**2019 SMP Package II (Lyons St., Sligo St.)
Solicitation Number: CO-00203
Job No.: Water – 18-5009 Sewer – 18-5509**

**ADDENDUM 1
August 2, 2018**

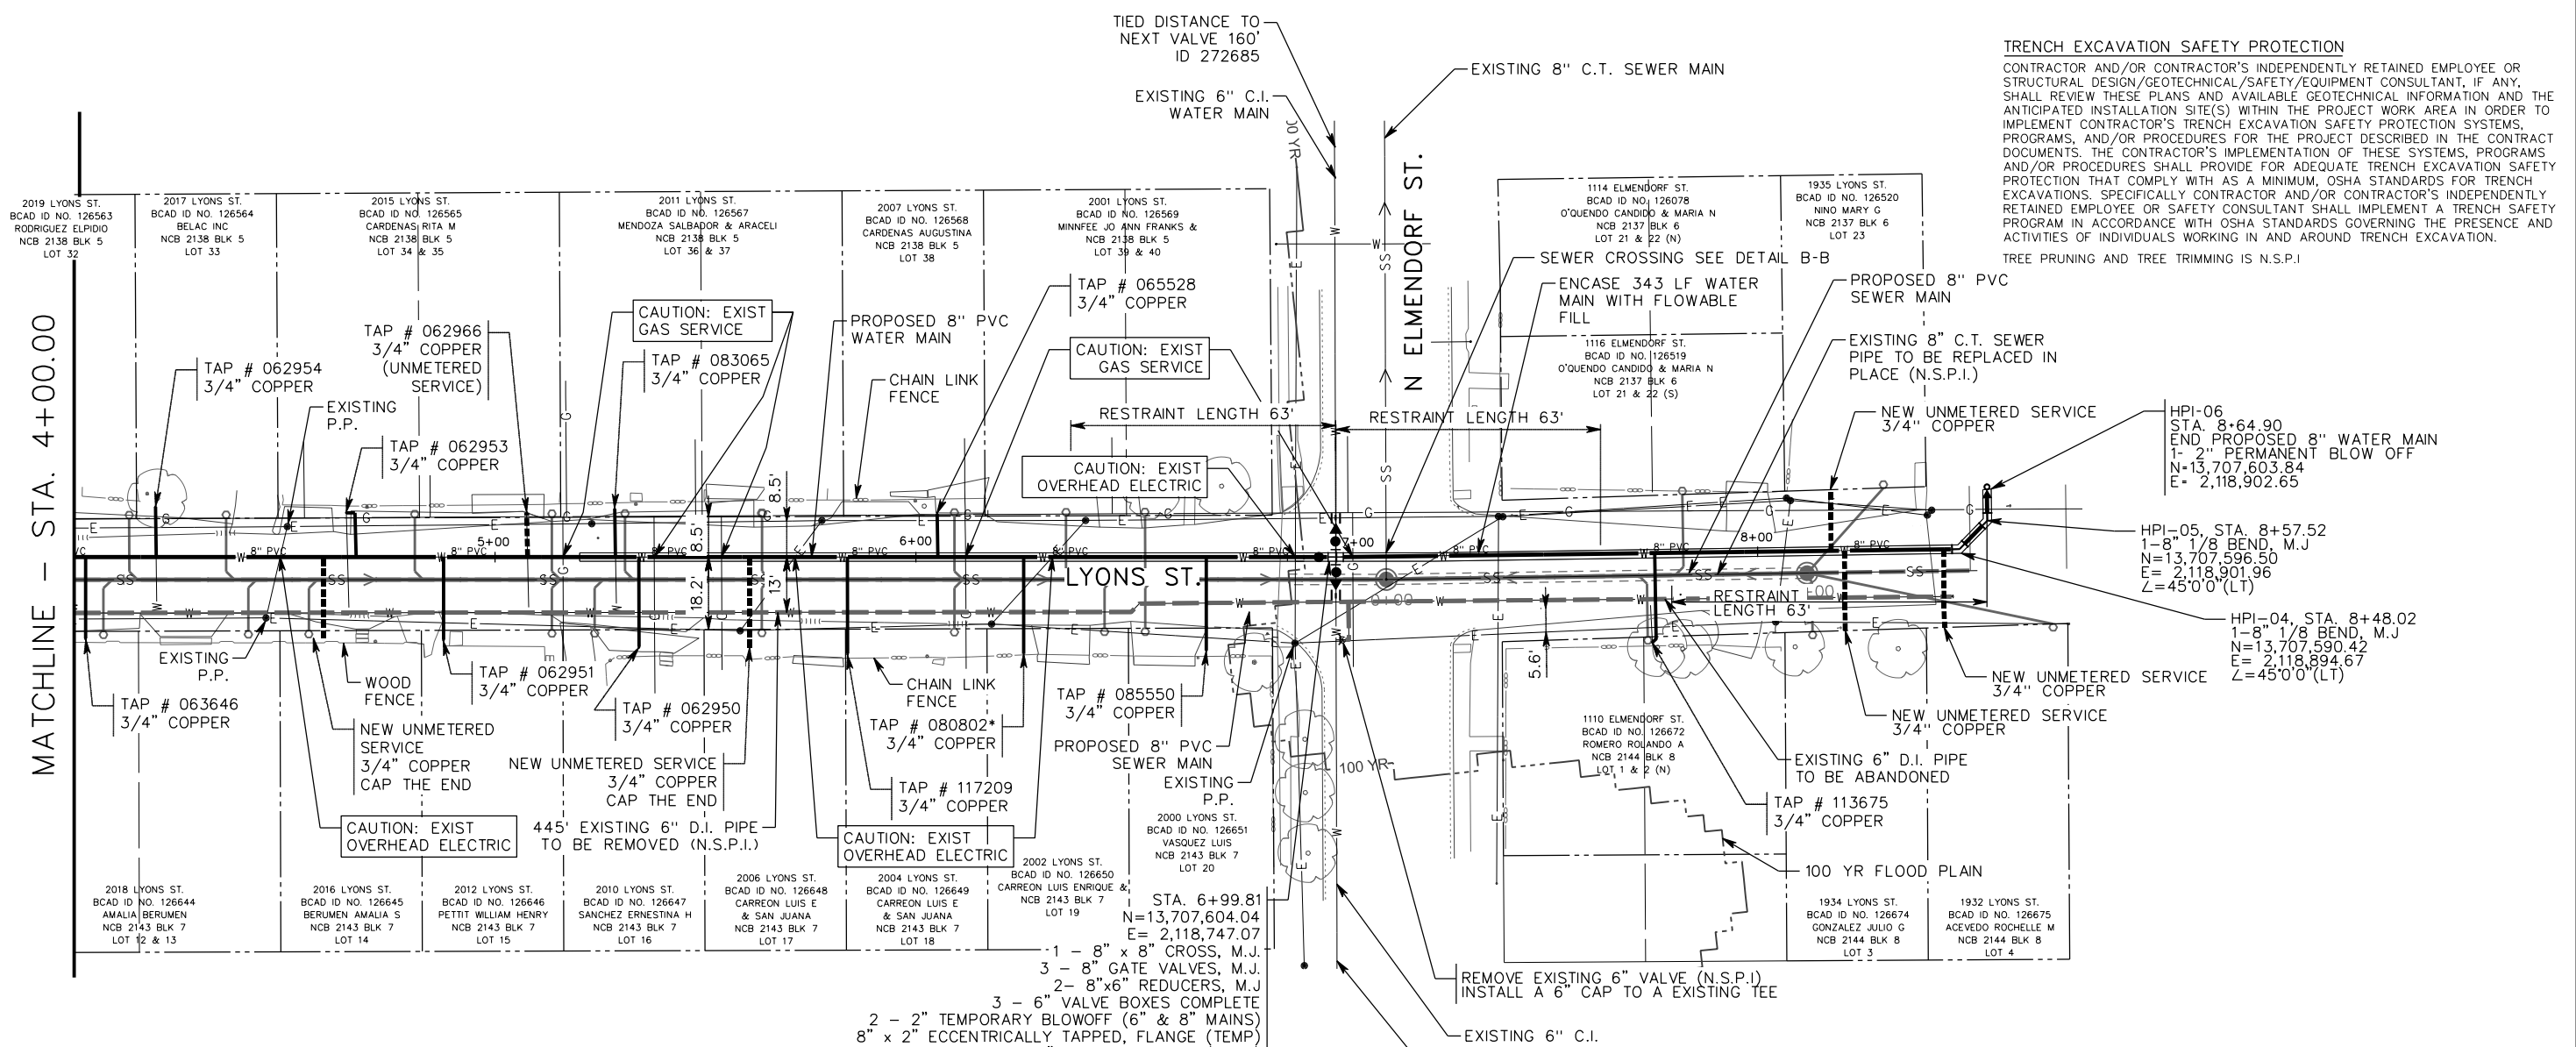
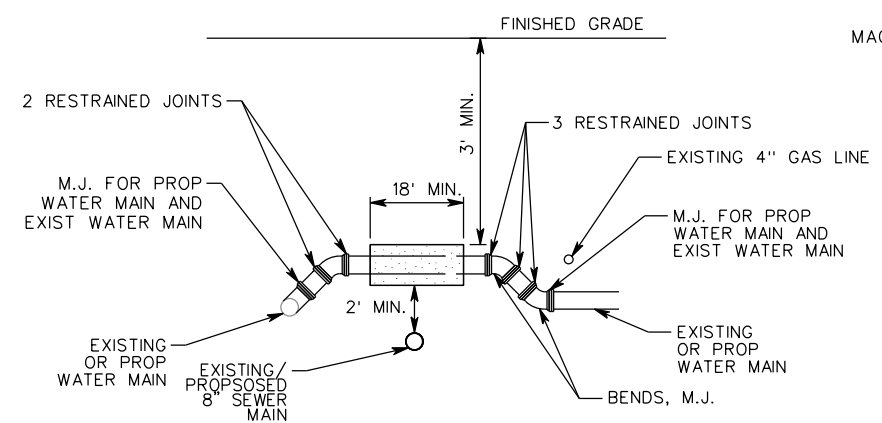
1. Replace the drawing plan set with the attached drawing plan set. Sheet 7 of 19 was revised to show the existing 6" CI water main along N. Elmendorf Street to be located on the west side of N. Elmendorf Street.
